ADDENDUM NO: 02

PROJECT NAME: Washington Co. Sheriff's Office Remodel  
PROJECT ADDRESS: 1155 W Clydesdale Dr. Fayetteville, AR  
PROJECT NO: 2433

DATE: 11/08/2024

HIGHT JACKSON ASSOCIATES  
ROGERS, AR  
ARCHITECTS AND PLANNERS

A2.0A

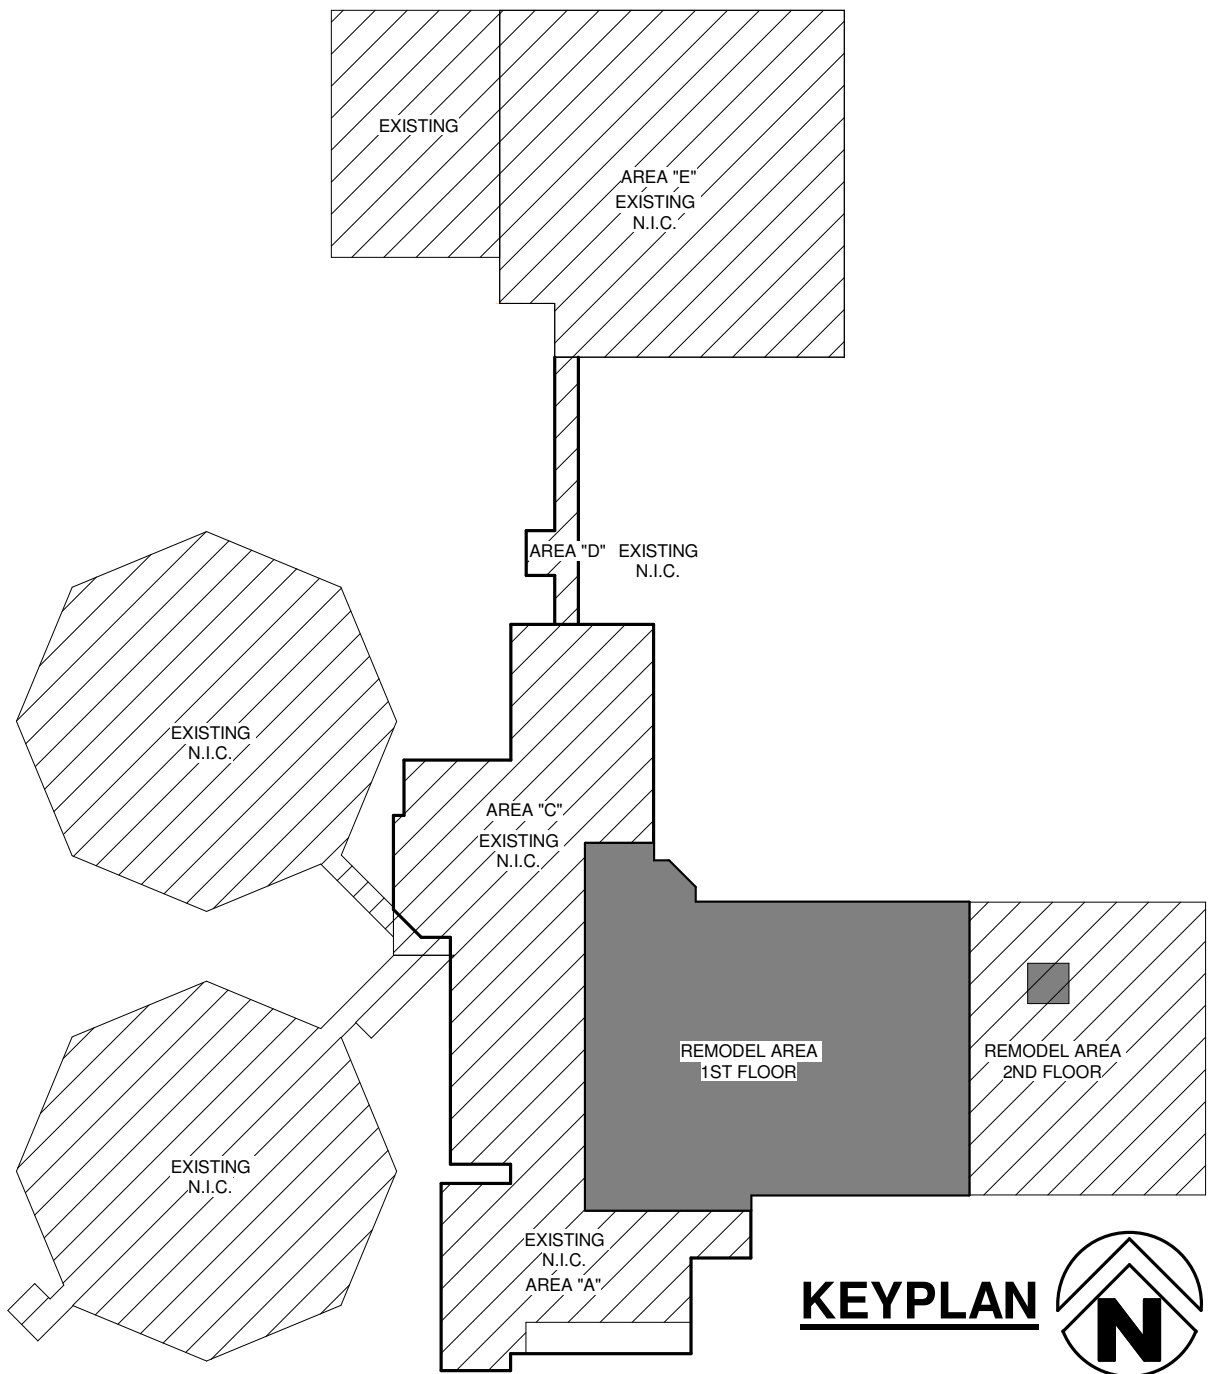
**Item No. 1: Refer to Architectural Sheet A2.0A, A2.0B and A2.1:**

- a) Existing door in room 109 was changed to demolish.
- b) Walls furr out has been changed to demolish.
- c) Adjustable mobile shelving system called out in demo and floor plan to be relocated is manufactured by Montel Inc. Montel contact number is 601-750-7144.

LIGHTING PLAN  
SHEET  
**E2.1**  
COPYRIGHT 2024  
THESE DRAWINGS AND SPECIFICATIONS ARE  
THE EXCLUSIVE PROPERTY OF  
HIGHT JACKSON ASSOCIATES P.A.  
USE OR REPRODUCTION IS PROHIBITED  
WITHOUT WRITTEN CONSENT

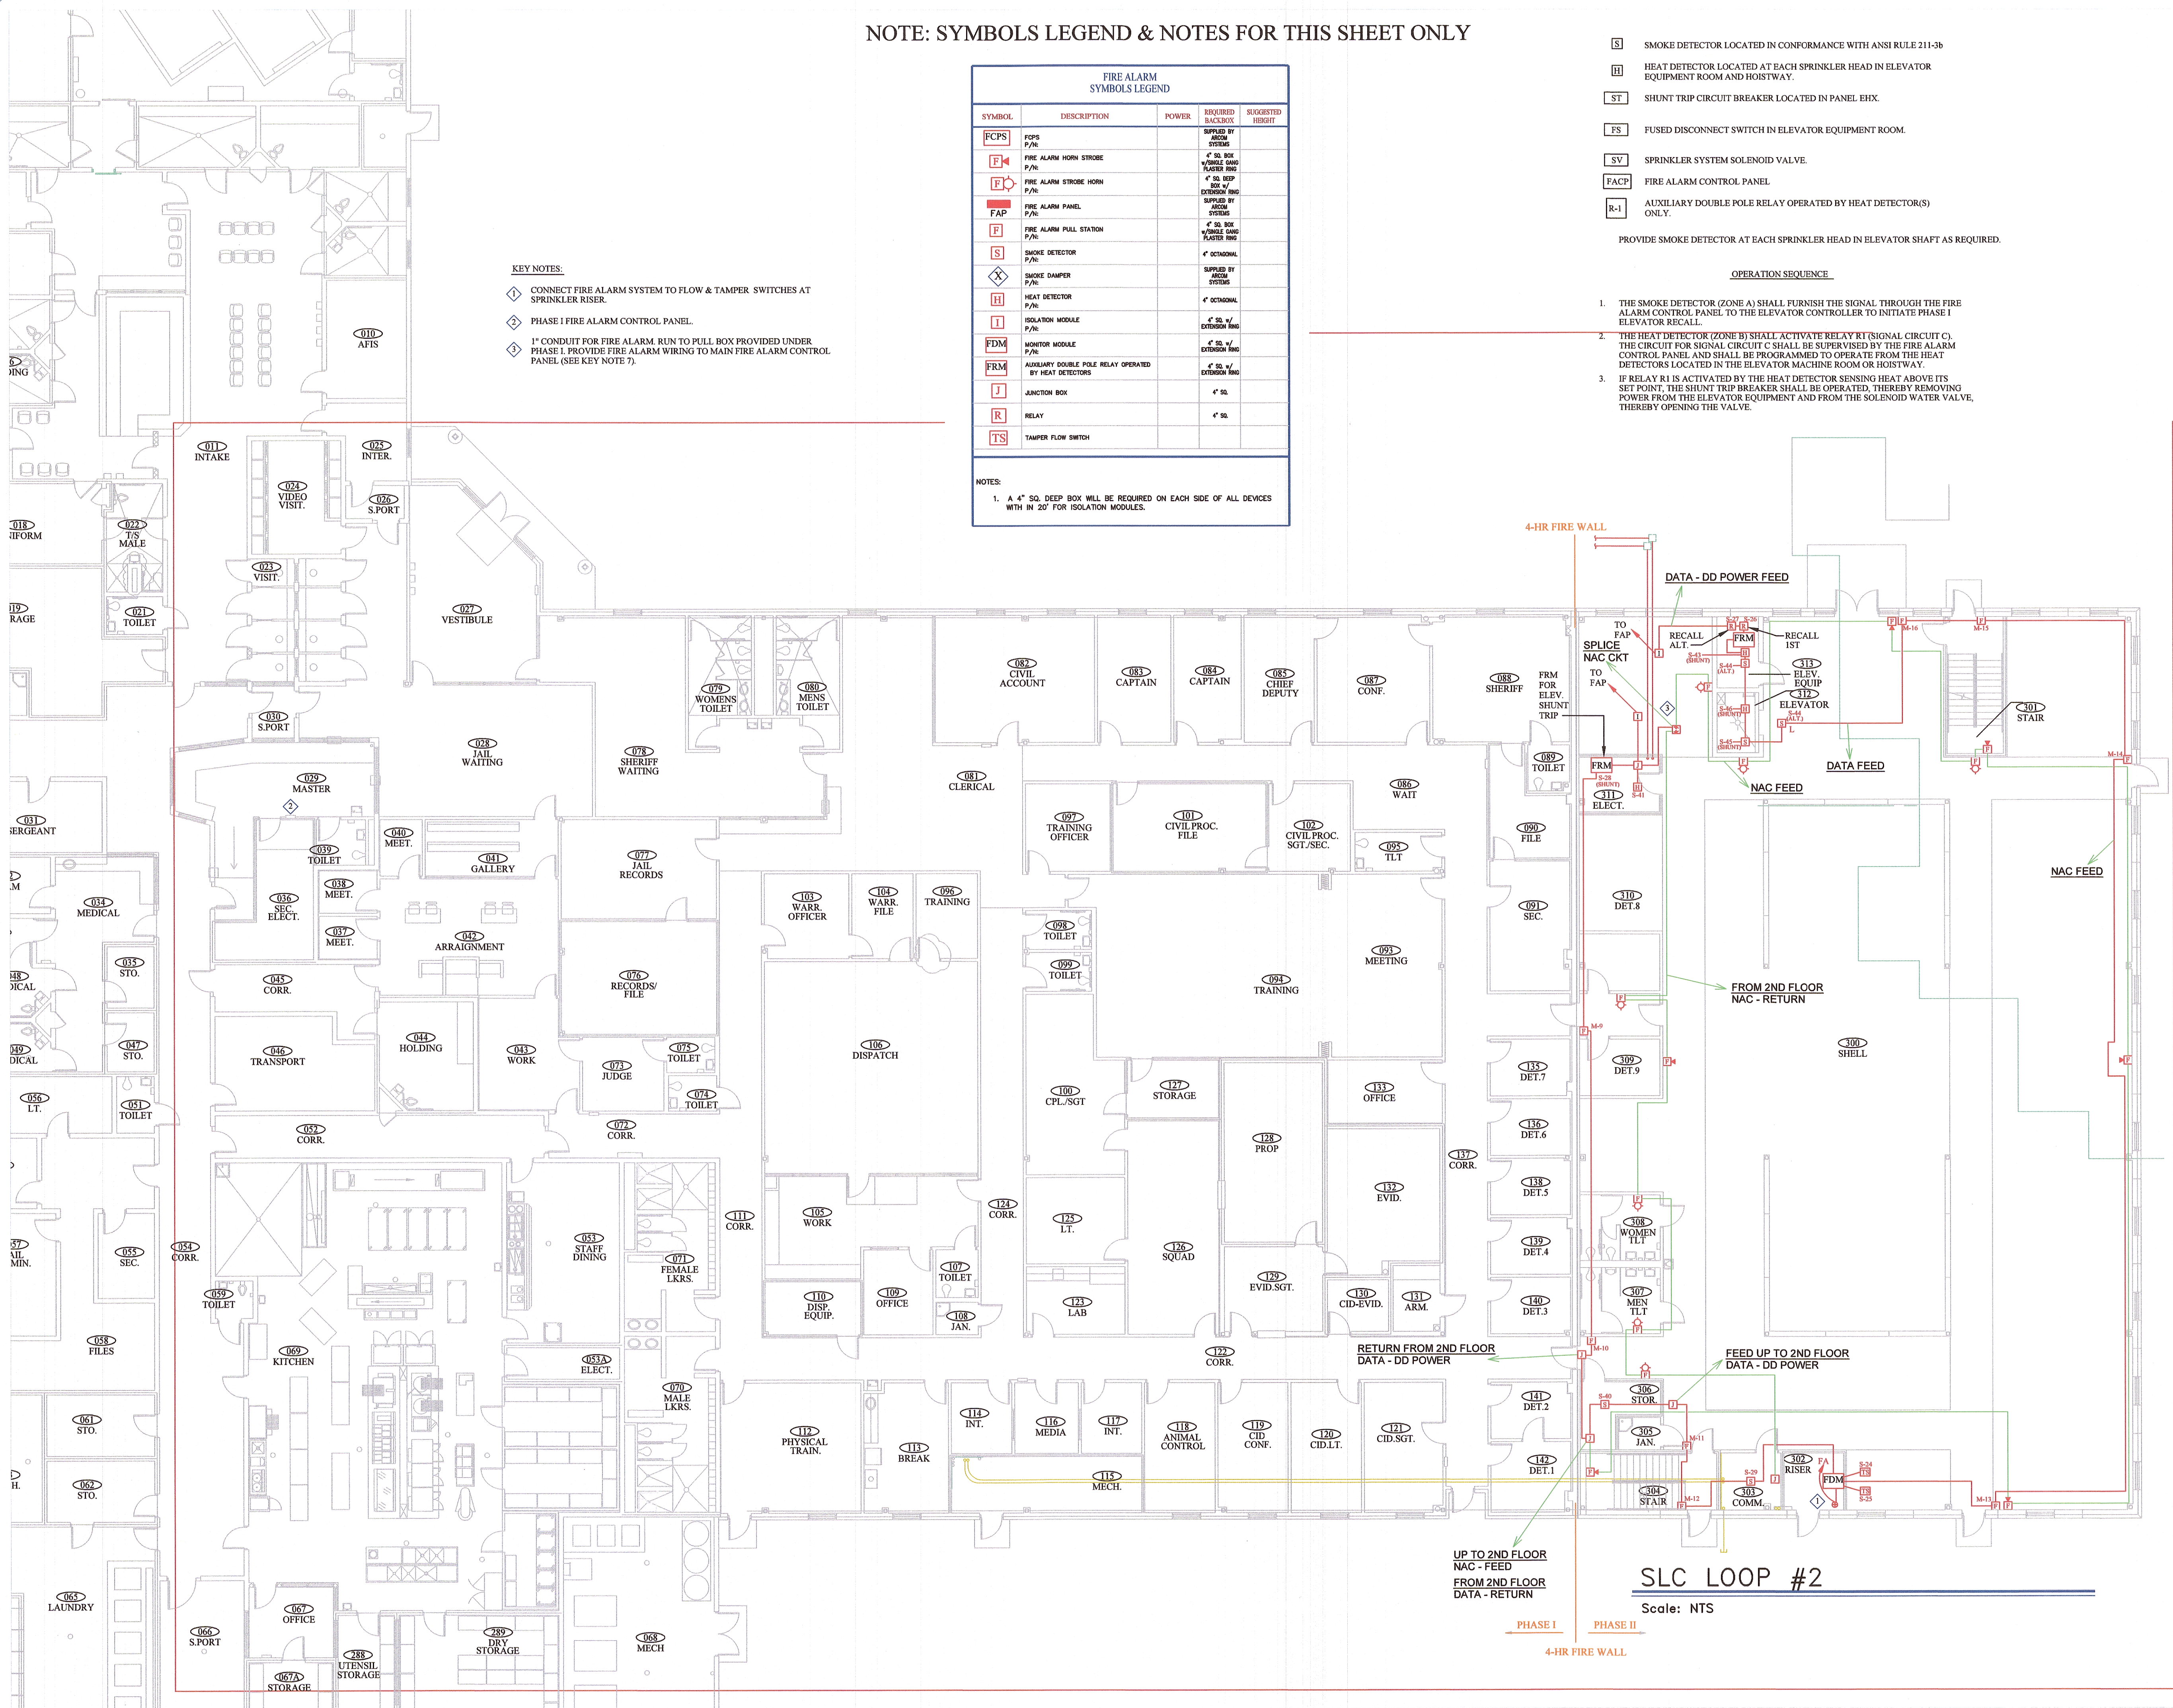
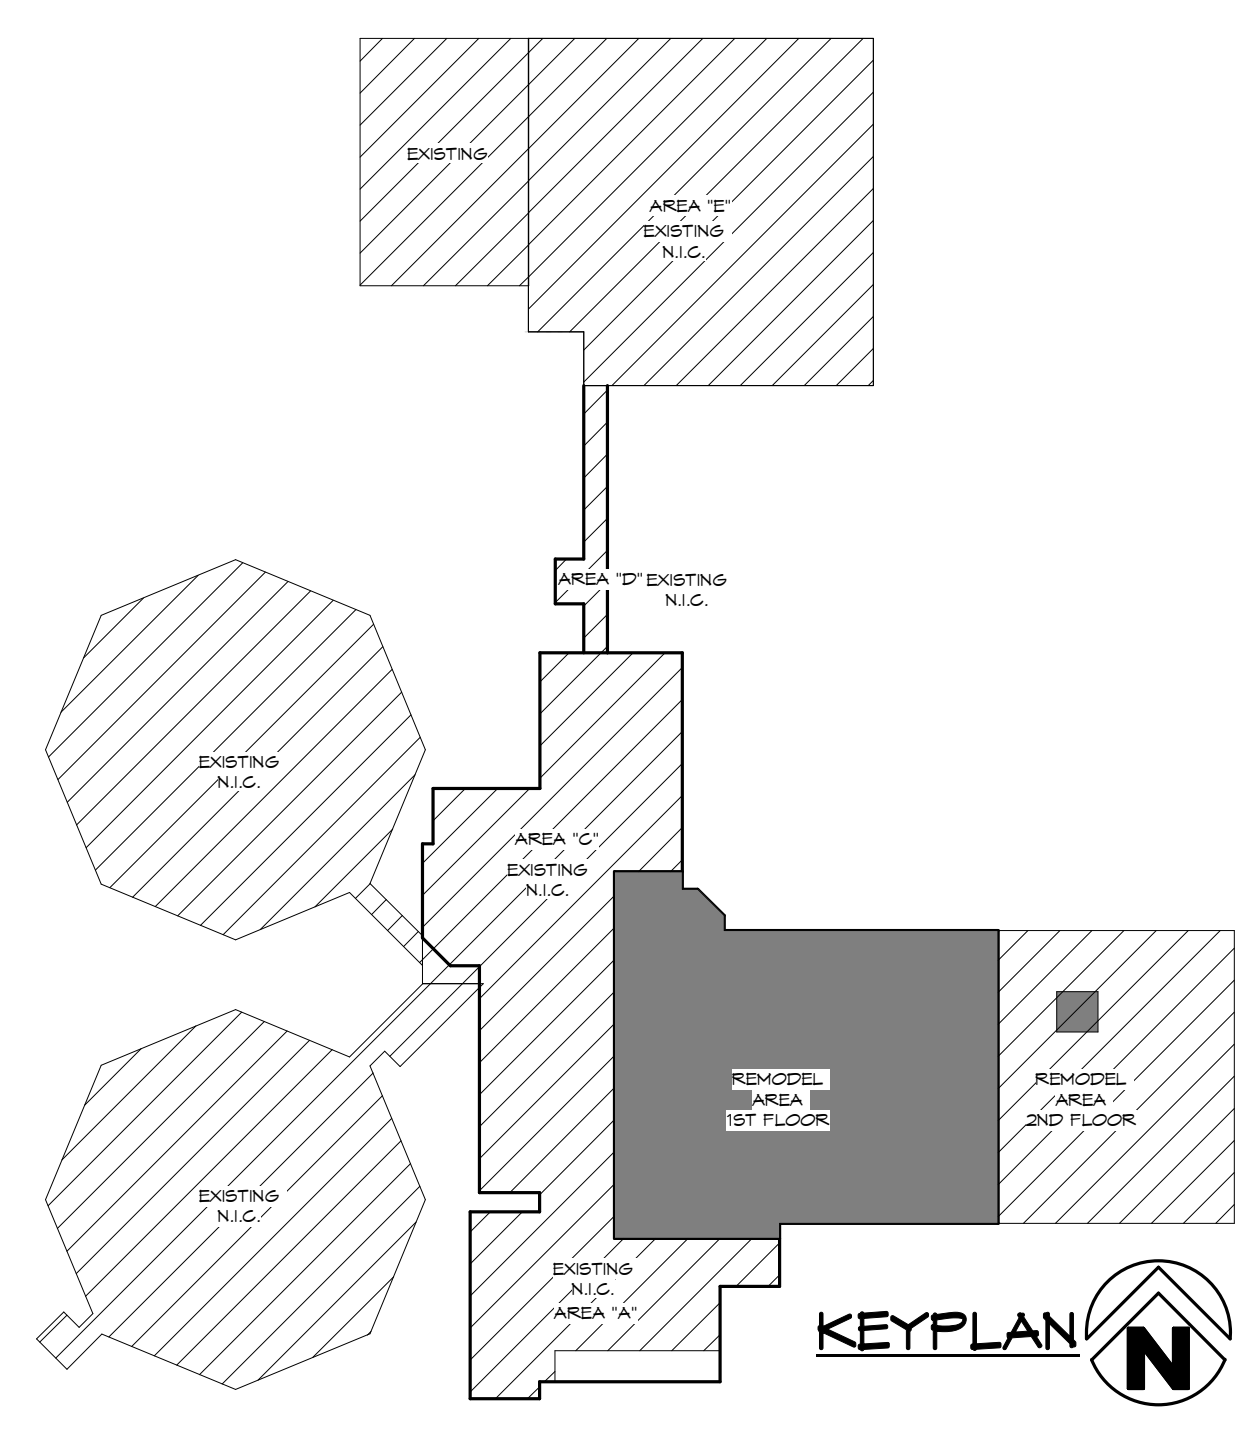
**Item No. 2: Refer to Attached Revised Electrical Sheet E2.1:**

- a) Revised lighting in rooms A110, and 107.
